Service Bulletin

Bulletin No.: 18-NA-114

Subject: Intermittent Service All Wheel Drive (AWD)/Service Stability Messages and/or Low Oil Pressure Shut Off Engine Message Displayed in Driver Information Center (DIC), Erratic Speedometer Readings, No Crank, Malfunction Indicator Lamp (MIL) Illuminated - DTC P0641, P2535, U0073, U0100, U0101, U0121, U0131, U0136 and/or U1814 Set

Brand:	Model:	Model Year:		VIN:		Engine:	Transmission:
		from	to	from	to		
Chevrolet	Trax	2018	2020	—	—	1.4L (LUV)	—

5040432

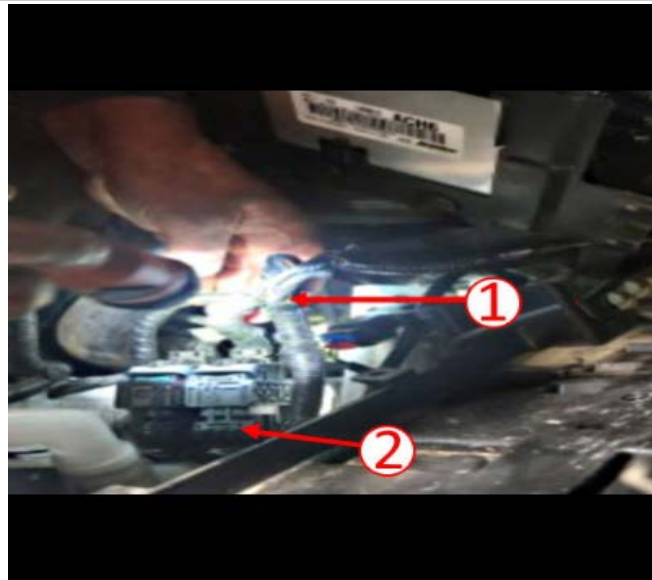
Cause	<p>Note: This is a multi-wire bundled harness and, depending on which wire is damaged, can set a variety of DTCs.</p> <p>This condition may be caused by the engine harness chaffing against the G100 Ground stud.</p> <p>This condition may be caused by damage to the engine harness near the X112 connector.</p> <p>⇒ Inspect G103 (refer to bulletin 19-NA-068)</p>

1. With a suitable light, inspect the wiring harness point of contact at the G100 ground stud.
- ⇒ For stud location, refer to Document ID#: 4708510 in SI.
2. Repair the harness as needed.
- ⇒ Refer to *Wire to Wire Repair* in SI.

3. Using Woven Polyester Electrical Tape (PET), tape all the contact points of the engine harness ensuring that the tape is applied in a double layer.
 4. Reposition the engine harness so that it cannot contact the ground stud.
- ⇒ If required, replace the blown fuse in regards to repair performed on the engine harness.
